Re: Order on Consent ("CSO Order"), (DEC Case #C02-2011 0512-25, modification to DEC Case #C02-0000107-8), Appendix A, IX. Westchester Creek CSO, G. Submit Approvable Drainage Basin Specific LTCP for Westchester Creek

Response to DEC's September 22, 2014 Comments on the June 2014 Combined Sewer Overflow Long Term Control Plan for Westchester Creek

November 24, 2014

Figure 8-4 Revised – Cost vs. Volumetric CSO Control

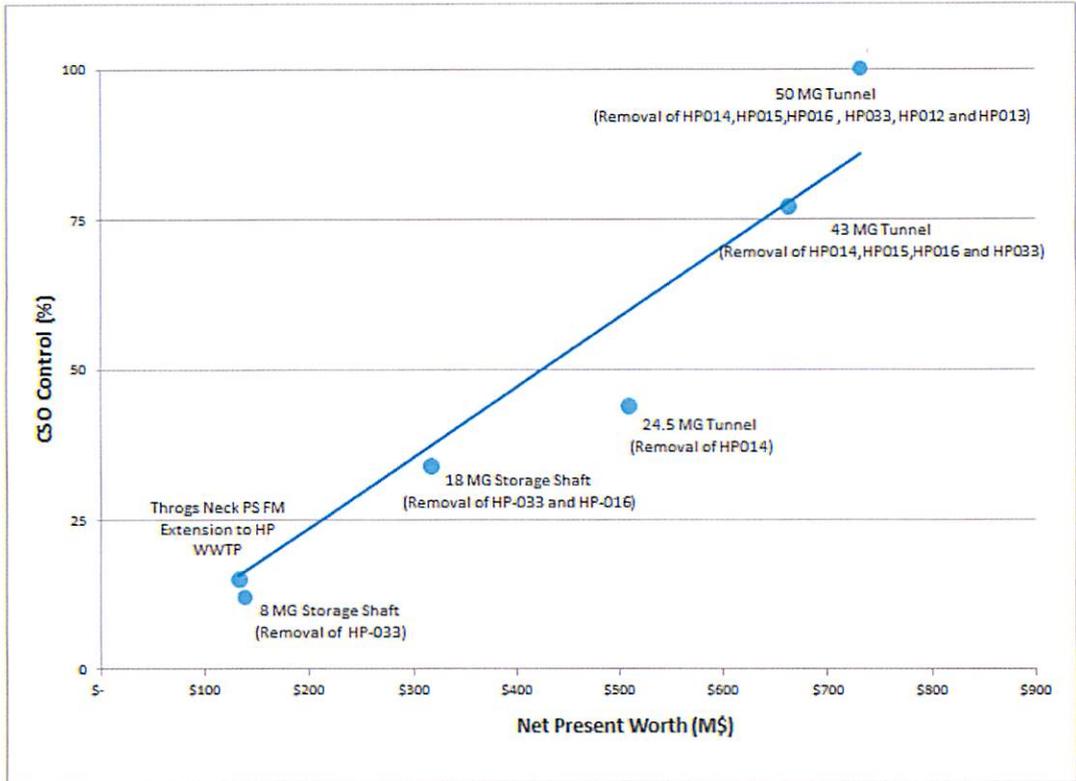
3. Evaluation of Alternatives. “The LTCP included limited information on the evaluation of some alternatives. The City must provide results for the knee of the curve analysis for the in-line storage, in-line storage plus disinfection, and green infrastructure alternatives as well as Treatment Shaft (see attached AET brochure) and other technologies identified in the EPA document: http://water.epa.gov/scitech/wastetech/upload/Chapter-4_Mar-2013_508.pdf.”

Vertical Treatment Shaft (VTS) Storage: *DEP chose to evaluate three tunnel storage configurations which spanned a wide range of volumetric CSO control levels, along with in-line storage rather than the VTS technology for storage. In response to DEC’s comment, VTS storage is evaluated herein. For such evaluation, the shafts would be located where the tunnel shafts are shown on Figure 8-3. Two shaft sizes were considered: 8 MG and 18 MG. The smaller shaft for HP-033 would provide a level of volumetric control (12%) close to the optimal Throgs Neck PS alternative (15%). The larger shaft for outfalls HP-016 and HP-033 would provide a level of volumetric control*

(34%) which is somewhat between the optimal Throgs Neck PS alternative and the 8 MG shaft (15% and 12%, respectively) and the smallest of the three tunnels (44%).

A cost-performance curve showing these points is attached as revised Figure 8-4. It is essentially Figure 8-4 from the LTCP with the addition of the 8 MG and 18 MG shafts. As shown, because the 8 MG shaft and optimal Throgs Neck PS alternatives are nearly equal in performance and costs, non-monetary factors need to be considered to determine which technology would provide the most suitable solution for that level of volumetric control. These factors include the following:

- VTS storage is a less proven technology
- DEP has no operational experience with shafts for either CSO tunnels or storage
- DEP has considerable operational experience with PSs and FMs
- Siting would be greatly simplified with the Throgs Neck PS alternative
- Once the FM is built, there would be no permanent O&M disruptions or inconveniences to abutting property owners
- Refurbishment of the PS would be an ancillary benefit

Thus, had VTS storage been considered, the Throgs Neck PS alternative would have been favored for the lower level of volumetric control, the 12% to 15% range.
